March 27, 2026

Re: SB25-0014 – Hillcamp RidgeGate Preliminary Plan No.1 – 4th Review Comments

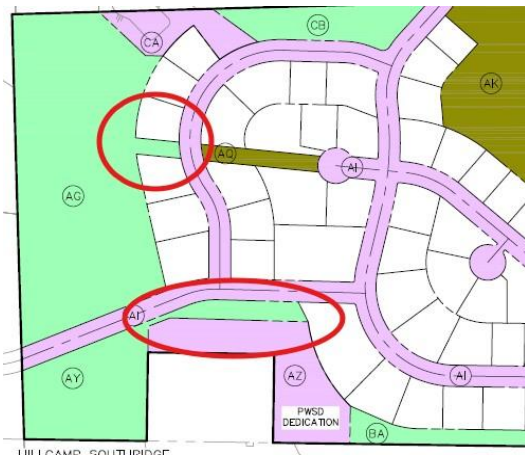
2. Per the City's previous comments on the topic, the plan provides insufficient wildlife movement corridors and does not satisfy the Commitment II of the RG PD, which requires a wildlife preservation plan. The Preliminary Plan does not integrate the elements identified in the Wildlife Preservation Plan submitted for the project. For example, the Wildlife Preservation Plan states that a minimum 45' wildlife movement corridor will be provided on the southern boundary of the

project; this is not provided, and no continuous wildlife movement corridor is provided on the southern boundary of the project. Again, the impacts of the project must be accounted for within the scope of the project boundaries; the applicant cannot rely on lands outside of the project area to accommodate or mitigate development impacts. Additionally, as previously identified by the City, insufficient wildlife movement corridors are provided throughout the project, to include in the center of the project area; several wildlife road crossings are identified in the Wildlife Preservation Plan, however, wildlife movement corridors are not provided to facilitate safe crossings and the design of the lot and road layout will force wildlife to utilize the road corridors for movement, which is inconsistent with the RG PD. For example, a major wildlife movement corridor is represented below with the red arrow; this movement corridor funnels wildlife into a crossing that is too narrow for safety (less than 25') and that then routes wildlife through a narrow tract surrounded by homes (Tract BG).

Applicant Response: The updated site plan includes a 45-foot-wide continuous wildlife corridor along the entire southern boundary of the Preliminary Plan area intended to facilitate east–west wildlife movement through the site. The design team has also evaluated potential wildlife fragmentation and updated the site plan to improve corridor functionality by relocating trail alignments outside of designated wildlife corridors and modifying roadway crossing locations that previously interrupted continuous land flow, helping to reduce disturbance and maintain more continuous open space along the southern portion of the site.

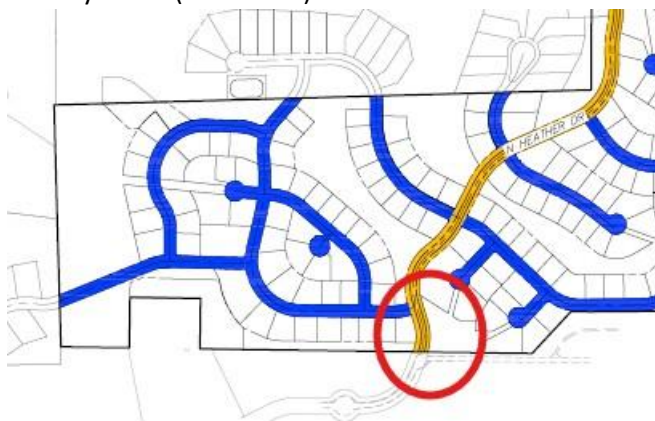
3. In Note #4, correct spelling of “MAINTAIND” as it is currently identified.

Applicant Response: Note updated.

Sheet 23

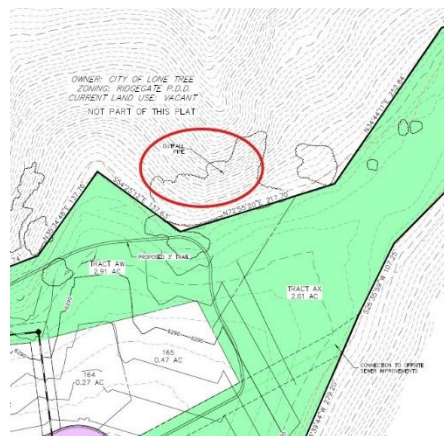
1. Additional detail on the construction of the proposed outfall pipe from the pond in Tract AV is needed. See comments on Geotechnical Investigation Report above for additional detail.

Applicant Response: Refer to the supplemental Drainage Outfall Design Memo included with this submittal for additional detail on pond outfall pipes.

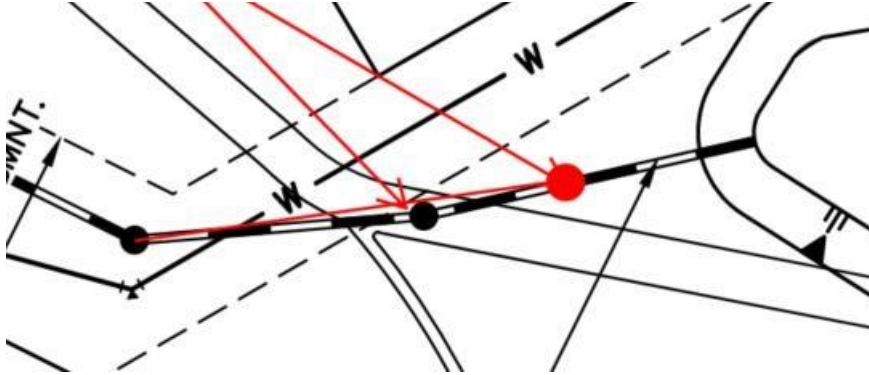
17. The sanitary sewer line and Pond J appear to be conflicting, please provide separation between the two so that the easements and grading are not conflicting. Our preference would be to not have the sanitary sewer line adjacent to the pond in the event the sewer has a failure and leeches into the pond.

Applicant Response: Pond J has been relocated to the cul-de-sac and is no longer in open space.

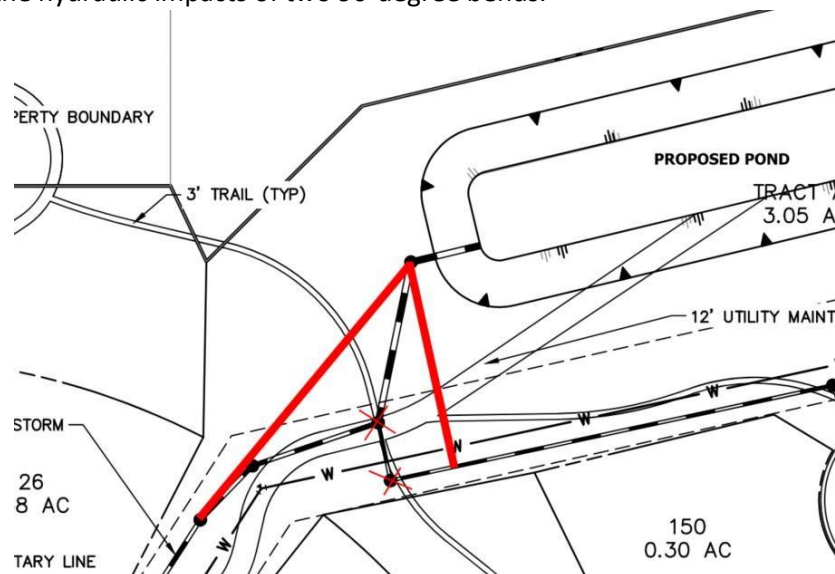
27. Pond H outfall may contribute to trail erosion, please consider alternatives, or culverts at trail.

Applicant Response: The Applicant acknowledges the potential for trail erosion associated with the Pond H outfall. As the design progresses, culverts or other appropriate drainage conveyance measures beneath the downstream trail will be evaluated and incorporated as necessary during final design to ensure that stormwater flows are safely conveyed and that the trail remains protected from erosion or washout.

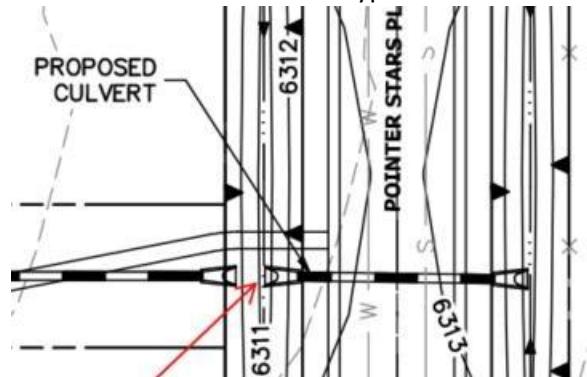
30. Ensure adequate access, emergency overflow, and positive drainage from Pond D.

Applicant Response: An emergency overflow route for Pond D is proposed through an overland drainage channel located within the drainage easement between adjacent lots, which will safely convey overflow flows downstream. Maintenance and access to Pond D will be provided via the adjacent cul-de-sac roadway. Due to the relatively shallow design depth of the pond (approximately 2–3 feet), this access arrangement will allow for adequate inspection and maintenance access while maintaining the intended drainage functionality of the facility.

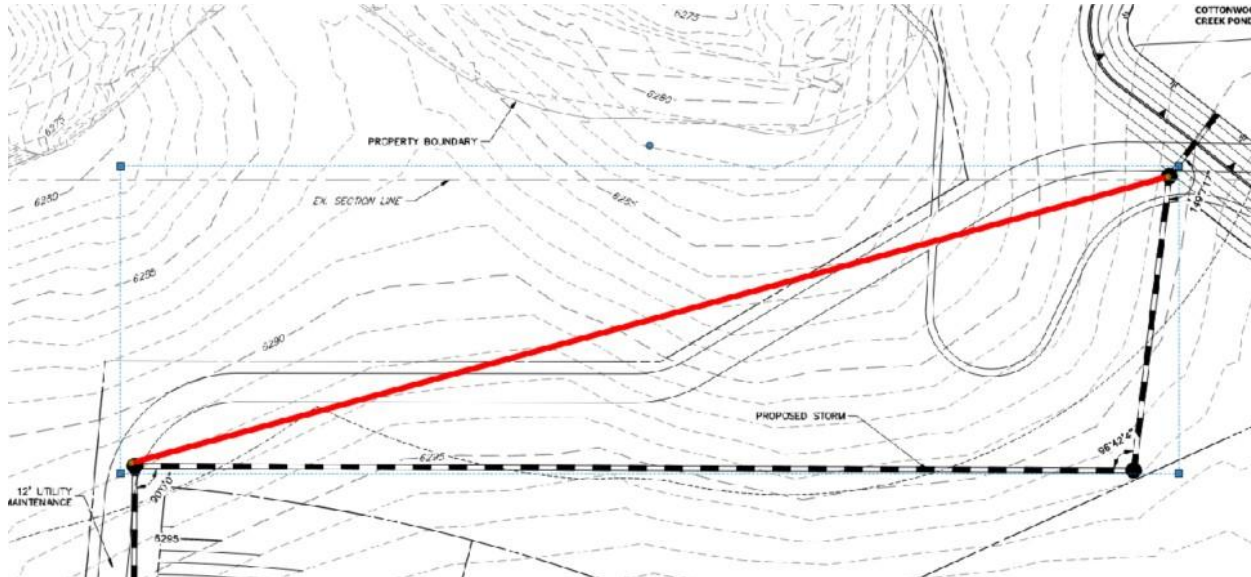
33. We will need to evaluate velocities at Pond K outfall, currently there is no riprap shown.

Applicant Response: Riprap now proposed at outfall for Pond K.
